## RESPONSE TO REVIEWER #2

***“In the paper "Sequential assimilation of satellite-derived vegetation and soil moisture products using SURFEX\_v8.0: LDAS-Monde assessment over the Euro-Mediterranean area", the authors are motivated "to increase monitoring accuracy" of land surface variables such as soil moisture (SM) and leaf area index (LAI) over the European Mediterranean region. They use a global Land Surface Assimilation system called "LDAS-Monde" to assimilate both SM and LAI in experiments to assess the effects on the model land surface variables. The model results are compared to independent observations of river discharge, land evapo-transpiration and different agricultural statistics and measures. I recommend that this paper undergo major revisions.[...]"***

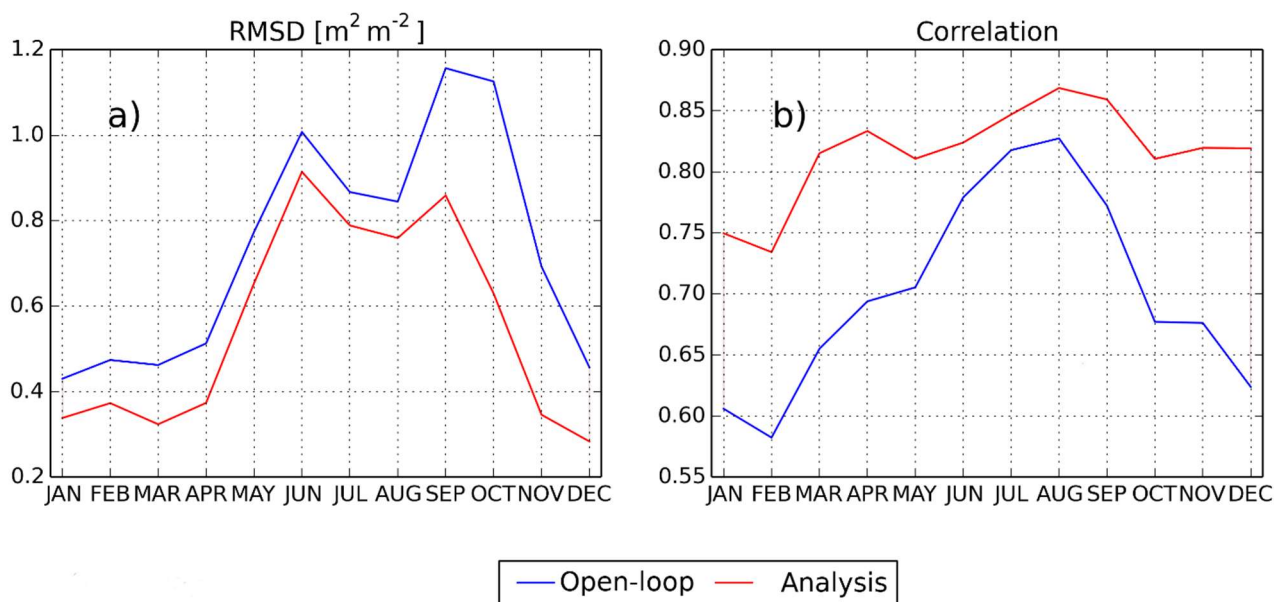
**2.56 [Figure 1. typo "righth" should be "right"]**

Agreed, new caption is: “*Averaged (left) surface soil moisture from the Climate Change Initiative project of ESA (right) GEOVI Leaf Area Index from the Copernicus Global Land Service project (for pixels covered by more than 90% of vegetation) over 2000-2012.*”

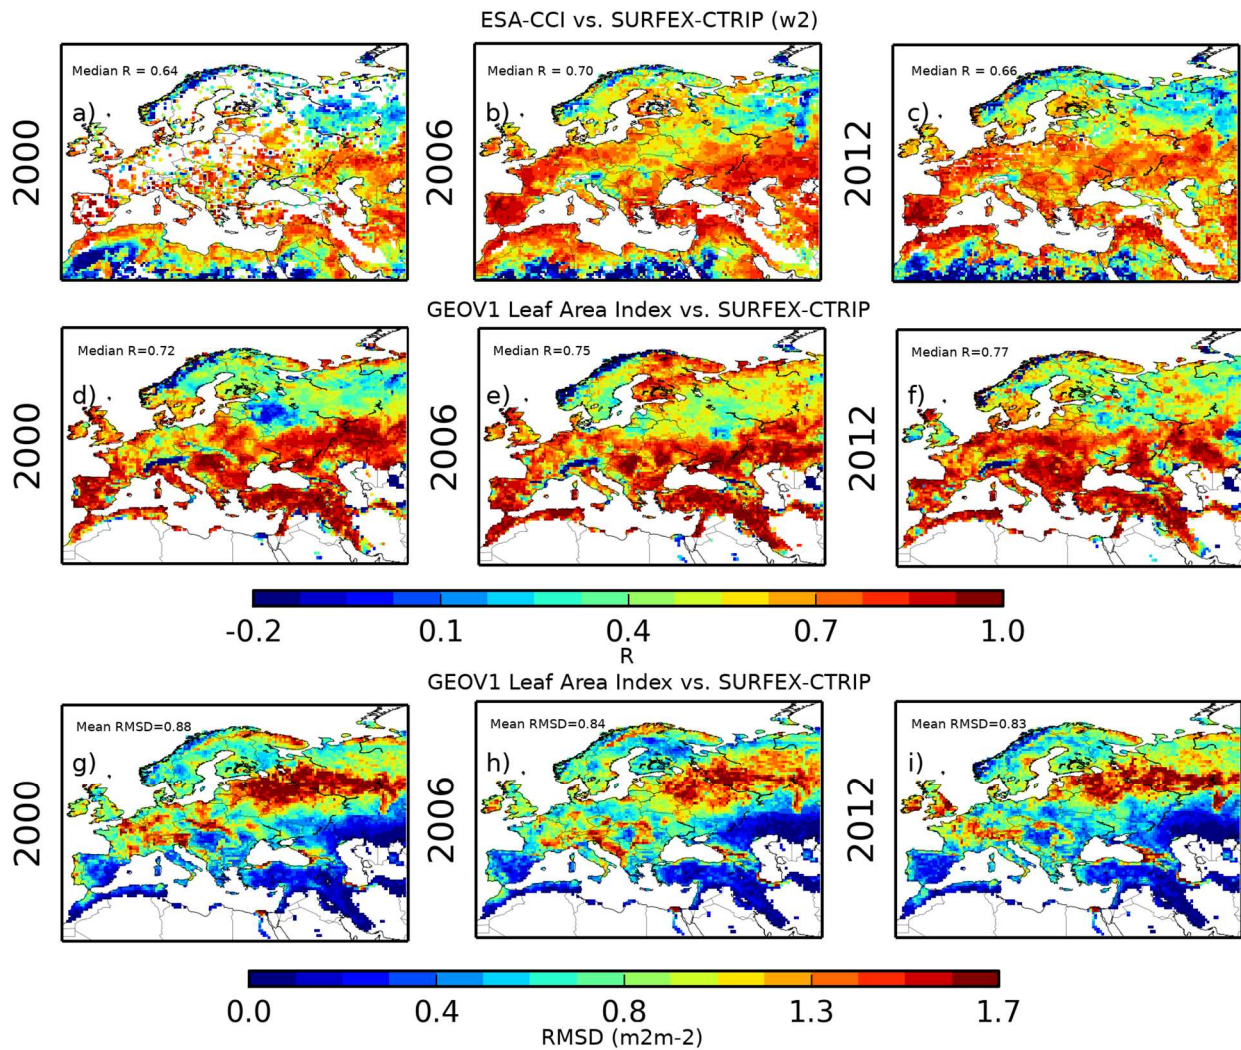
2.58 [Figure 3: The panels are very small. I think that all panels should be labeled a, b, c etc. and then referred to in the caption by letter. The top 6 panels appear to be for the median R values and the bottom is for a mean RMSD. This is not mentioned in the caption. What times are used in the creation of the median and mean? "Averaged values are reported..." which values are being averaged? In caption state that w<sub>2</sub> is the second layer of soil.]

Agreed, all panels are now labeled and referred to in the caption which is now : “*top row, yearly averaged correlations between satellite-derived surface soil moisture from the Climate Change Initiative project from ESA and the second layer of soil of SURFEX-CTRIP (w<sub>2</sub>: 1 cm-4 cm depth) for a) 2000, b) 2006 and c) 2012. d), e) and f) yearly averaged correlation between the GEOVI leaf area index from the Copernicus Global Land Service project and SURFEX-CTRIP for 2000, 2006 and 2012, respectively. g), h) and i) same as d), e) and f) for RMSD.*” New figure 3 is presented below.

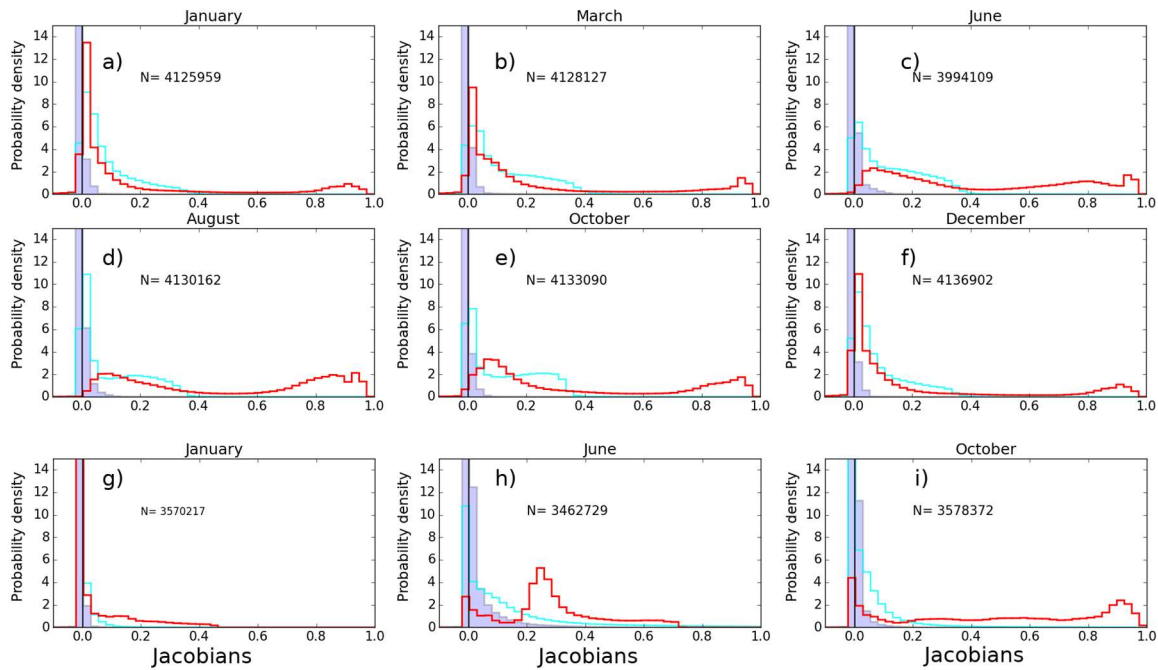
2.59 [Figure 4: Needs a label for the x axis. N is not defined in the caption but a number is given for N in each panel. The Jacobian elements need to match equation 9. There is a lack of superscript on the LAI variable. What are the solid blue lines in the histogram? Only the lines are defined in caption. Is there a vertical line drawn at 0.0? That should be stated because it is hard to see.]

Indeed information on N is missing, it represents the sampling. For sake of clarity on figure 4, the 90% confidence interval was chosen to define the upper and lower values to exclude outliers on the histograms. In agreement with Reviewer #2 comment, y-label is now 'Probability density', x-label is now 'Jacobians' and the Jacobian elements match equation 9 and all panels are labelled. New caption is: "*Jacobian values distribution: a) to f),  $\frac{\partial SS^t}{\partial w_2^0}$  (red line),  $\frac{\partial SSM^t}{\partial w_4^0}$  (cyan line) and  $\frac{\partial SSM^t}{\partial w_8^0}$  (blue line) all months of January, March, June, August, October and December over 2000-2012, g) to i),  $\frac{\partial LAI^t}{\partial LAI^0}$  (red line),  $\frac{\partial LAI^t}{\partial w_4^0}$  (cyan line) and  $\frac{\partial LAI^t}{\partial w_8^0}$  (blue line) for all months of January, June and October over 2000-2012. Black solid line represents a value of 0.*" New figure 4 is presented below.

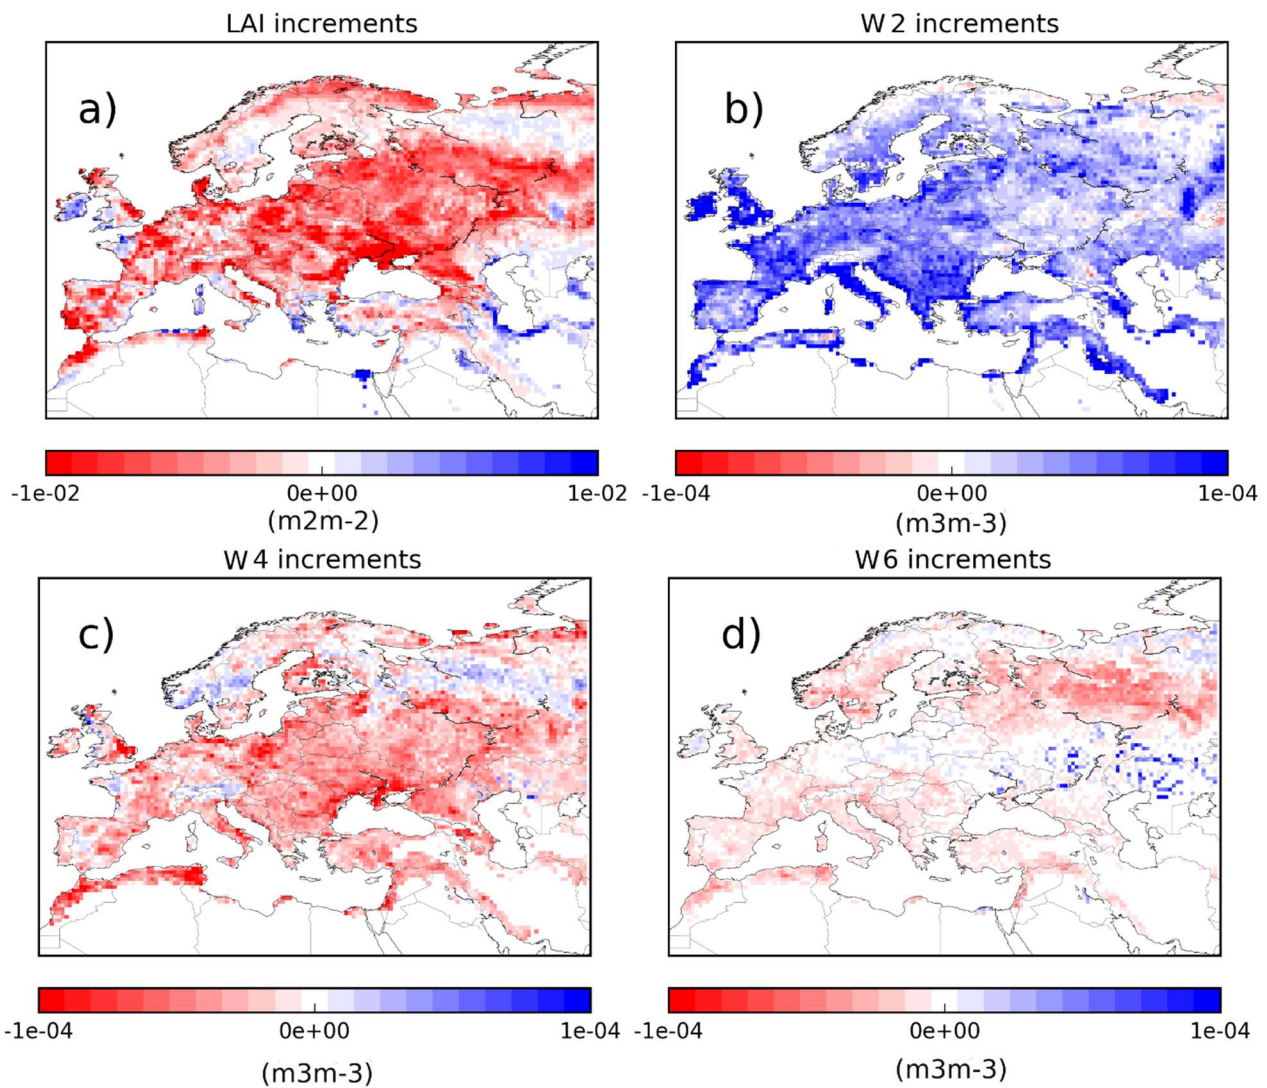
2.60 [Figure 5: State which column is which and which row is which. "Rows from top to bottom represent averaged analysis increments for all months Feb, May, Aug and Nov from 2000-2012...."]

Agreed, new caption is: "Rows from top to bottom represent averaged analysis increments for all months of February, May, August and November over 2000-2012. From left to right for 4 control variables are illustrated, leaf area index and soil moisture in the second ( $w_2$ , 1 cm- 4 cm), fourth ( $w_4$ , 10 cm-20 cm) and sixth ( $w_6$ , 40 cm – 60 cm) layer of soil, respectively."

GEOV1 Leaf Area Index vs. SURFEX-CTRP

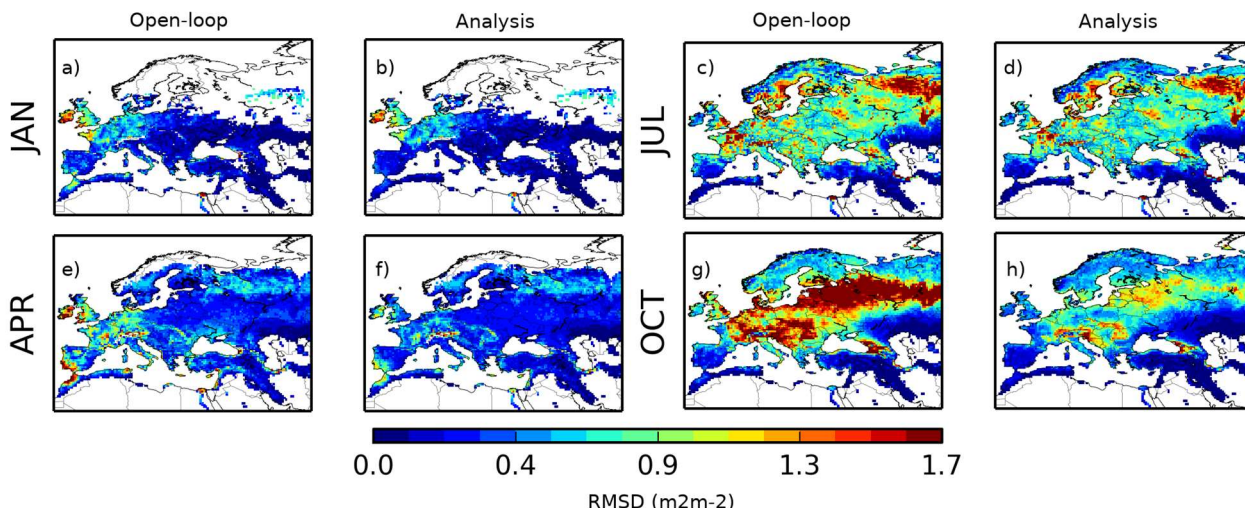
**2.62 [Figure 7: Panels need labels a, b,c and they need to be referenced as such in the panels.]**

Agreed, labels are now reported and all panels and captions has been changed accordingly: “*RMSD maps between leaf area index from the open-loop (analysis) and that from the Copernicus Global Land Service project (GEOV1 index) for a(b) January, e(f) April, c(d) July and e(f) October over 2000-2012.*” New figure 7 is presented below.

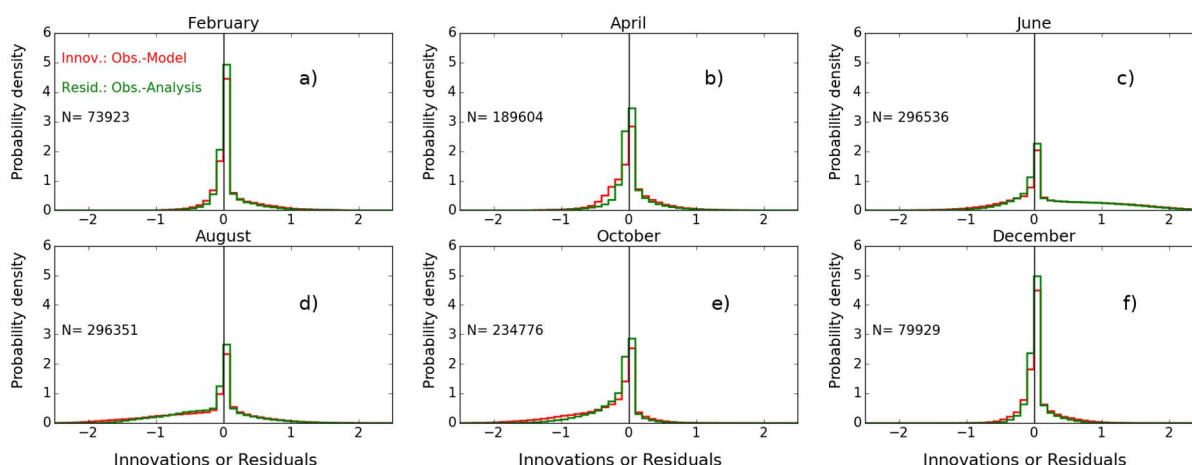
**2.6 [The figures (details are given in the technical comments below) need work as well. For example, in Figure 8: What is N? You don't really need a legend for the red and green lines on each of the 6 month plots. Just define this in the caption. Panels need labels a, b,c and they need to be referenced as such in the caption. Please label the x axis with variable name and units. Most importantly, the y-axis is not a probability but a frequency of occurrence (the caption even says "histogram" which is correct). The integral of the probability distribution function should be equal to one by definition.]**

2.63 [Figure 8: What is N? You don't really need a legend for Red and Green on each of the 6 month plots. Just define in the caption. Panels need labels a, b,c and they need to be referenced as such in the panels. Label the x axis. y-axis is not a probability but a frequency of occurrence. Integral of the Probability function should be equal to one.]

Agreed, figures have been improved accordingly. Please see also Responses to technical comments 2.56 to 2.68. Regarding the y-axis of figure 8, it should be labelled 'Probability density', it represents the counts normalized to form a probability density, i.e., the area (or integral) under the histogram will sum to 1. This is achieved dividing the count by the number of observations times the bin width and not dividing by the total number of observations. Y-labels on figures 4, 8 and 11 (b, c and d) are now 'Probability density'.

Information on N is indeed missing, it represents the sampling which is reported on each month plots. In agreement with Reviewer #2 comment legend for Red and Green are only reported on the first plot, panels are labelled a, b, c...etc, x-axis is now 'Innovations or Residuals' and y-axis is 'Probability density' (please see also response to comment 2.6). New caption is: *“Probability density function of innovation (observations-open-loop in red) and residuals (observations – analysis, in green) for Leaf Area Index for a) February, b) April, c) June, d) August, e) October and f) December over 2000-2012. Sampling (N) is reported on each panel”*. New figure 8 is presented below.

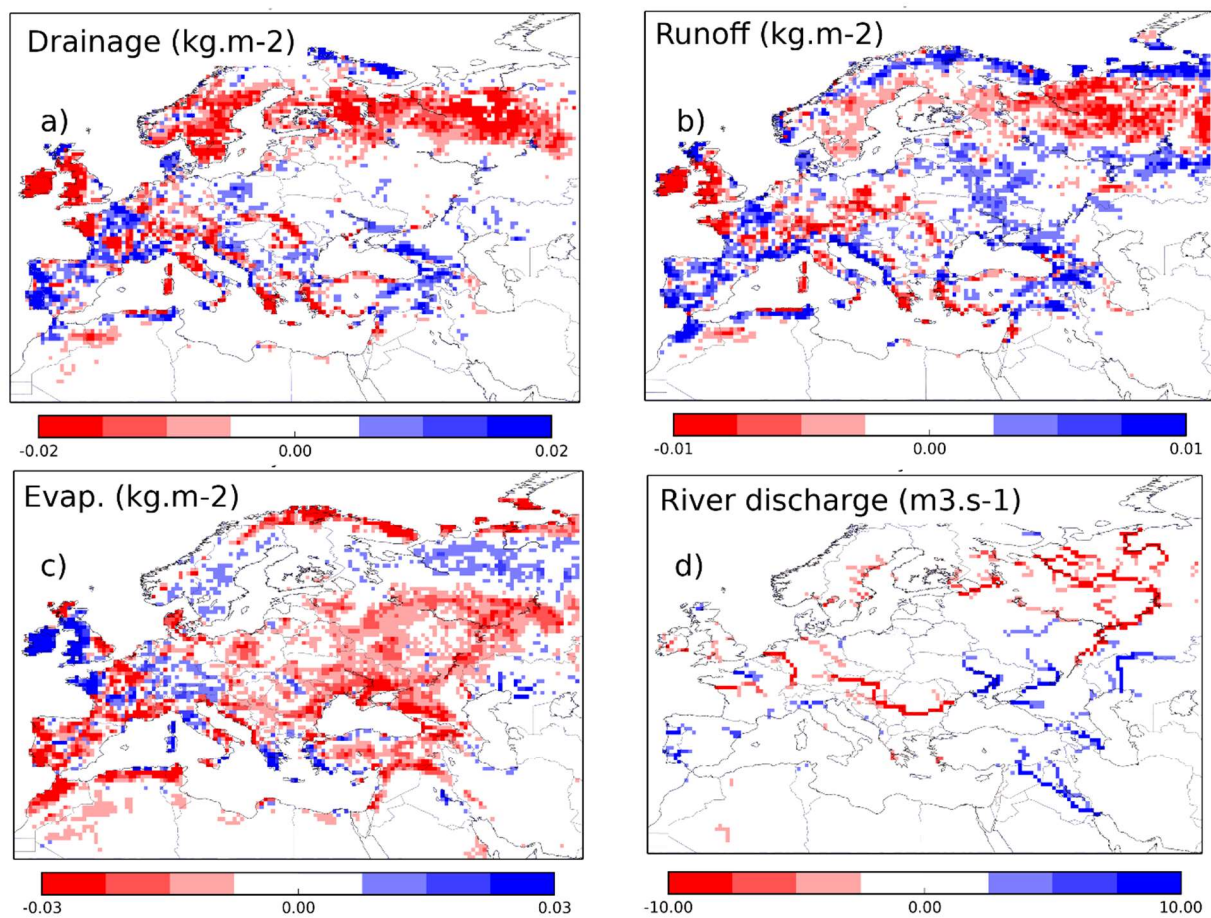
2.64 [Figure 9: Panels need labels a, b,c and they need to be referenced as such in the panels.]

Agreed, panels are now labeled and the new caption is: “*Averaged analysis impact on land surface variables that are indirectly affected over the period 2000-2012: a) drainage, b) runoff, c) evapotranspiration and d) river discharge.*” New figure 9 is presented below.

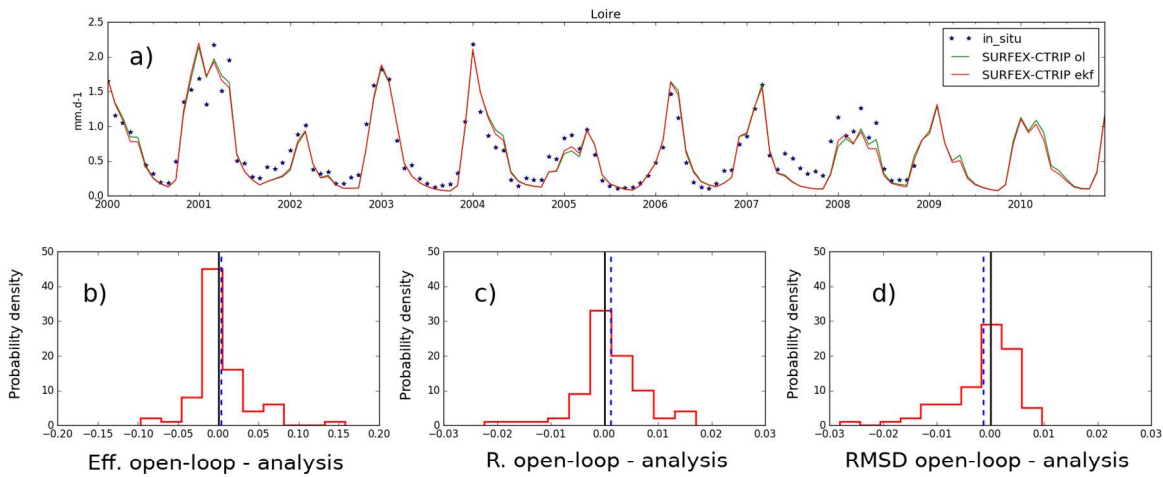
2.65 [Figure 10: In caption, please tell the reader what is Agreste?]

Agreed, new caption is: “*a); Correlation values for the above ground biomass from the open-loop with grain yields estimates from Agreste French agricultural statistics portal (<http://agreste.agriculture.gouv.fr>) over 45 sites in France plotted against correlations between the same quantities but above ground biomass from the analysis; b) same as a) for RMSD values; c) scaled anomalies time-series of above ground biomass from the open-loop (black dashed line) the analysis (black solid line) and grain yields observations (red solid) for one site in Allier, France (46.09N-3.21E).*”

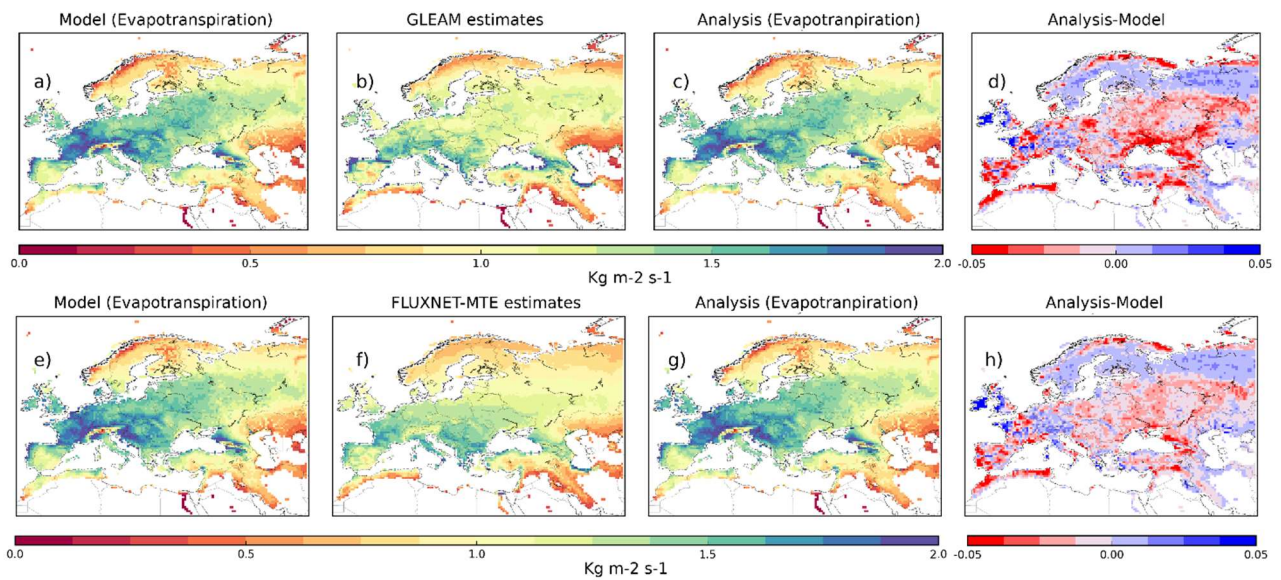
2.67 [Figure 12: The y axis is not labeled correctly. It should be latitude not 200001-201212. The multiple panels are very small and hard to see. I think that you could take the middle row and make it into a new figure. It is not about Evapotranspiration like the top and bottom rows. Please rewrite the second sentence. Be more explicit. For example: Maps of averaged taken over 2000-2012 of a) evapotranspiration...]

Agreed, y-label is removed and as suggested by Reviewer #2 this figure is now split into 2 figures, one for Evapotranspiration (new figure 12) and one for Gross Primary Production (new figure 13). It also makes them more visible for Readers. New captions and figures are:
